Access Compliance Report

Public Rights-of-Way

Intersection ID: 31500	Main Street: CARLEEN_WAY_DR	Cross Street: GRIER_SPRINGS_LN	Location: E
ADA ID: 9D334CA08C32	Ramp Type: PerpDiag	Initial Pass/Fail: Fail	Overall Compliance: No
Severity Score: 35			
Codes/Mitigation Info/Possible Solution		Field Measurements/Component Compliance

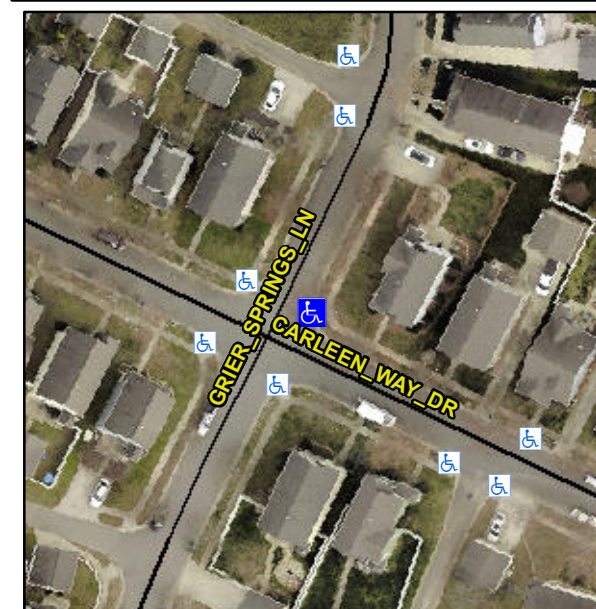
Not Found, R304.5.1

Compliance	Description	Data	Compliance	Description	Data
N/A	Ramp Length (in)	58.0	Yes	Ramp Slope (%)	5.3
No	Ramp Width (in)	29.5	Yes	Ramp XSlope (%)	0.6
N/A	Flare Type LT	N/A	N/A	Flare Type RT	N/A
N/A	Flare Slope LT (%)	N/A	N/A	Flare Slope RT (%)	N/A
N/A	Flare Traversable LT?	N/A	N/A	Flare Traversable RT?	N/A
N/A	Landing Length (in)	N/A	N/A	DWS Provided?	N/A
N/A	Landing Width (in)	N/A	N/A	DWS Contrast?	N/A
N/A	Landing Slope (%)	N/A	N/A	DWS Length (in)	N/A
N/A	Landing X Slope (%)	N/A	N/A	DWS Full Width?	N/A
N/A	Landing Curb? (Y/N)	N/A	N/A	DWS Offset (in)	N/A
N/A	Shared Landing?	N/A			
N/A	Gutter Ponding?	N/A	N/A	Gutter Slope (%)	N/A
N/A	Gutter Lip Ht (in)	N/A	N/A	Gutter X Slope (%)	N/A
N/A	Painted X Walk1?	No	N/A	Painted X Walk2?	No
	X Walk 1 Direction	To NW		X Walk 2 Direction	To SW
N/A	X Walk 1 Width (in)	N/A	N/A	X Walk 2 Width (in)	N/A
	X Walk 1 Slope (%)	0.5		X Walk 2 Slope (%)	4.5
	X Walk 1 X Slope (%)	0.8		X Walk 2 X Slope (%)	1.0

Remove & Replace Curb Ramp With Two New Directional Ramps or Equivalent.
